Improved Technical Specifications

Quad Cities Station

Volume 9:
Section 3.8

3.8 ELECTRICAL POWER SYSTEMS

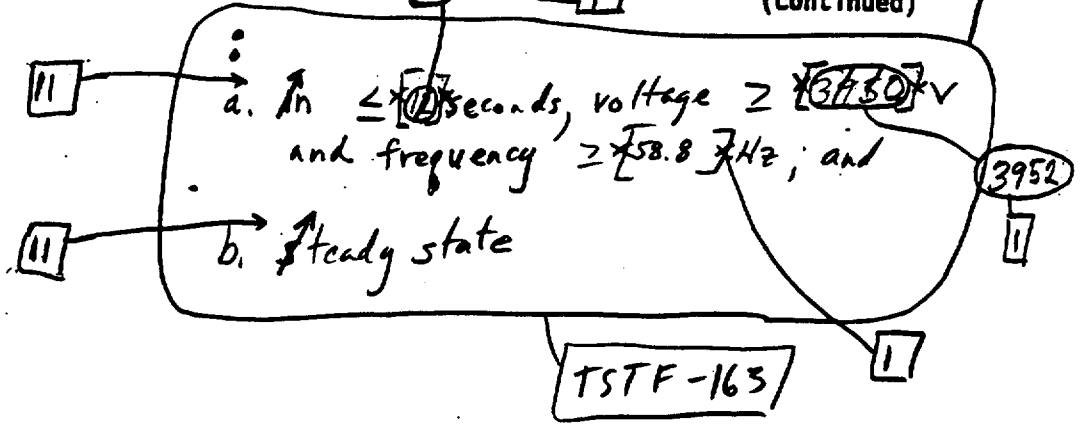
SURVEILLANCE	FREQUENCY
<p>SR 3.8.1.1. NOTE All DG starts may be preceded by an engine prelude period.</p> <p>Verify each DG starts from standby condition and achieves in ≤ 12 seconds voltage ≥ 3740 V and ≤ 4580 V and frequency ≥ 58.8 Hz and ≤ 61.2 Hz.</p>	<p>2. A single test of the common DG at the specified Frequency will satisfy the Surveillance for both units.</p> <p>184 days</p>
<p>SR 3.8.1.2. NOTE This Surveillance shall not be performed in MODE 1 or 2. However, credit may be taken for unplanned events that satisfy this SR.</p> <p>Verify automatic/and manual transfer of unit power supply from the normal offsite circuit to the alternate offsite circuit.</p>	<p>10 months</p> <p>24</p>

② TSTF-253

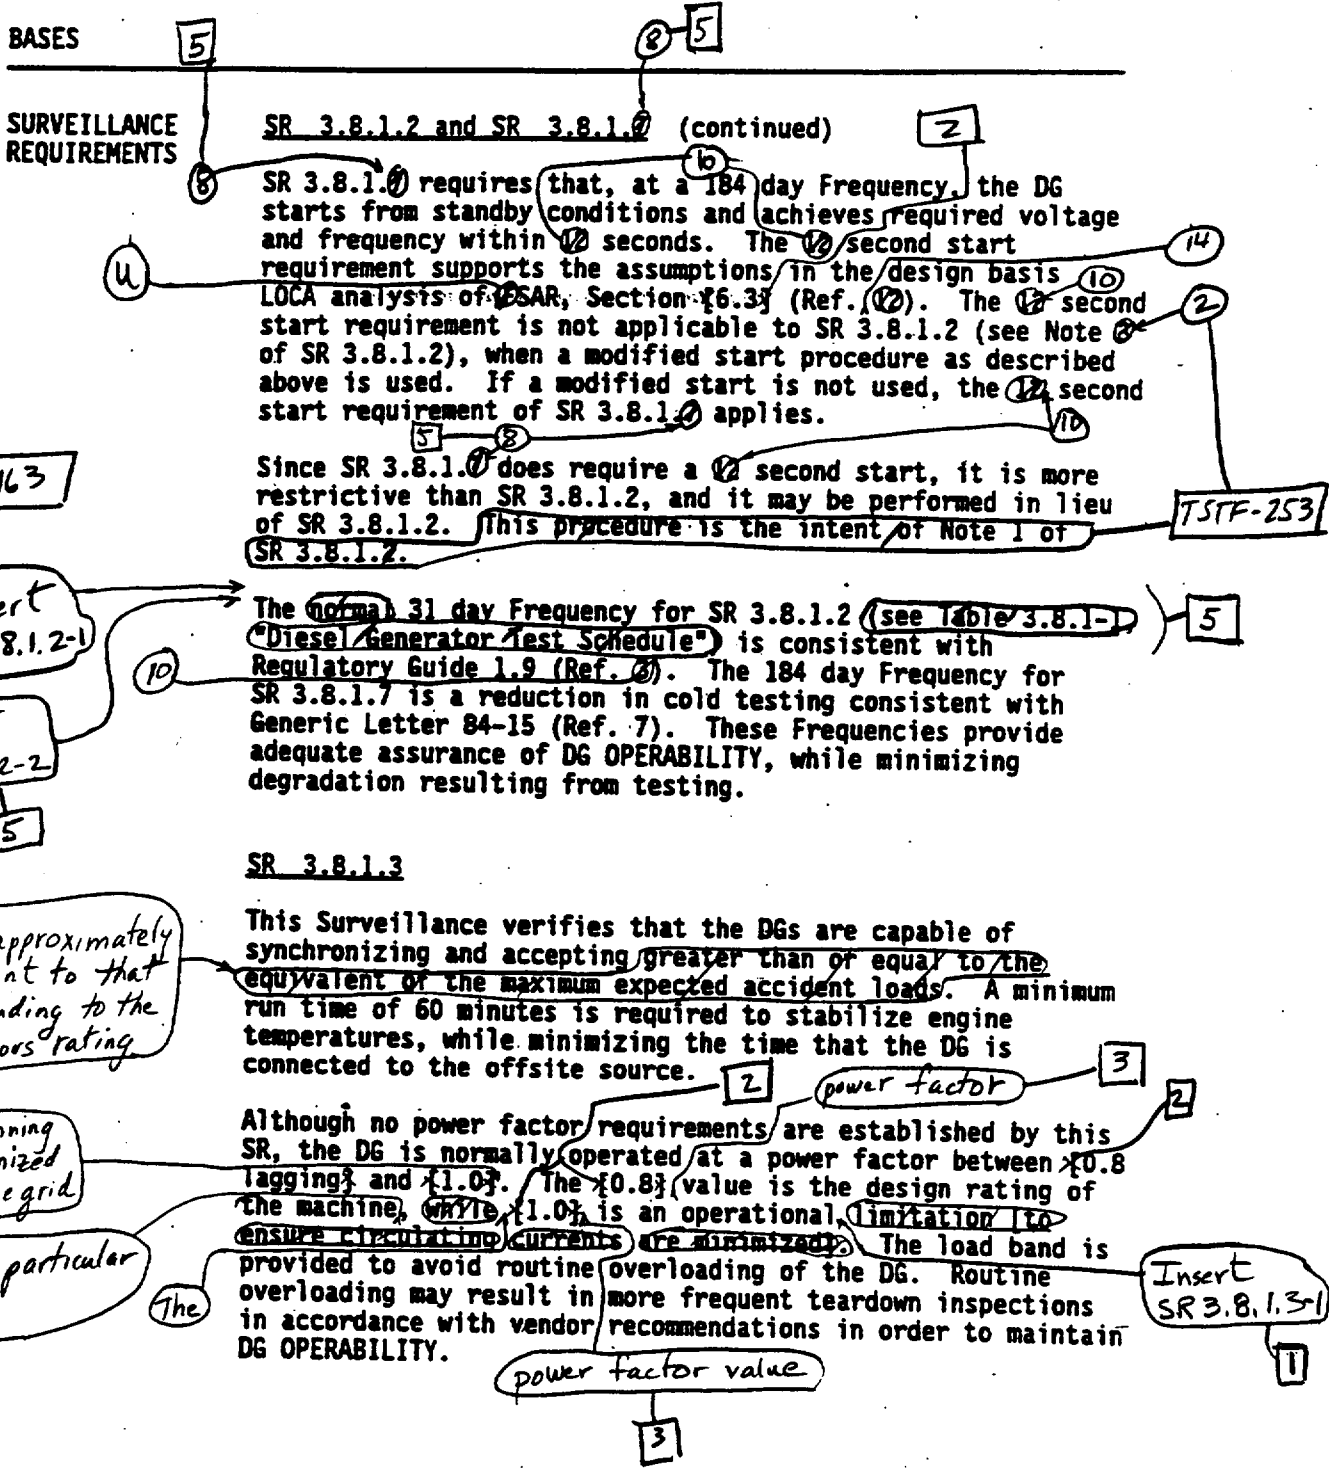
In order to ^{has} reduce stress and wear on diesel engines, ^{ex} manufacturers ^{the} recommend a modified start in which the ^{some} starting speed of DGs is limited, warmup is limited to this lower speed, and the DGs are gradually accelerated to synchronous speed prior to loading. These start procedures are the intent of Note ②, which is only applicable when such ~~modified start procedures~~ are recommended by the manufacturer.
